NUMBER: 23-034-15

Water Dripping From The Front Of The Sunroof

This bulletin involves replacing the sunroof front drain tubes.

2014 - 2015 (RT)

Fig. 1 Sunroof Front Drain Tube

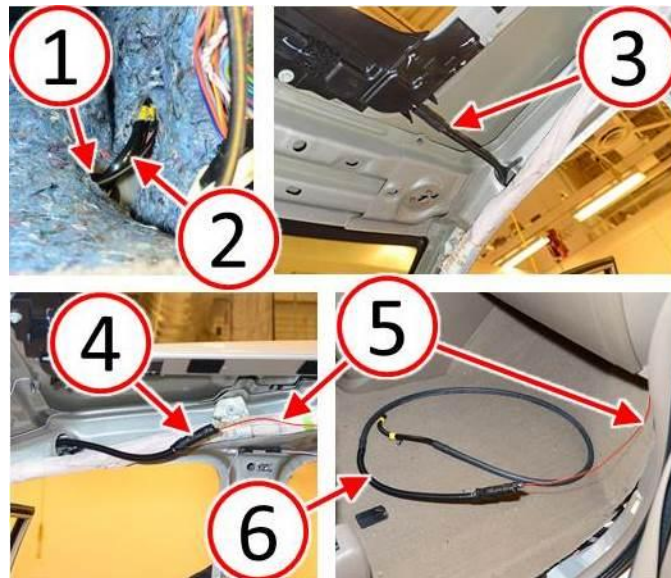
NOTE: The front drain tubes are routed inside the A-pillar. It will be necessary to attach with tape (4) a tether line (5) to the upper end of the drain tube (3) before removing the drain tube. The tether line will assist with installation of the new drain tube. Release the lower end of the drain tube (2) from the cowl grommet (1) then remove the drain tube (6) by pulling from the lower end of the tube while feeding the tether line into and down the A-pillar. Reverse this process by attaching the new drain tube (6) to the tether line (5) then pulling the tether line while feeding the new drain tube from the bottom, into and up the A-pillar.

Replace both sunroof front drain tubes. Refer to the detailed service procedures available in DealerCONNECT> TechCONNECT under: Service Info> 23 - Body> Sunroof> TUBE, Sunroof Drain> Removal/Installation.
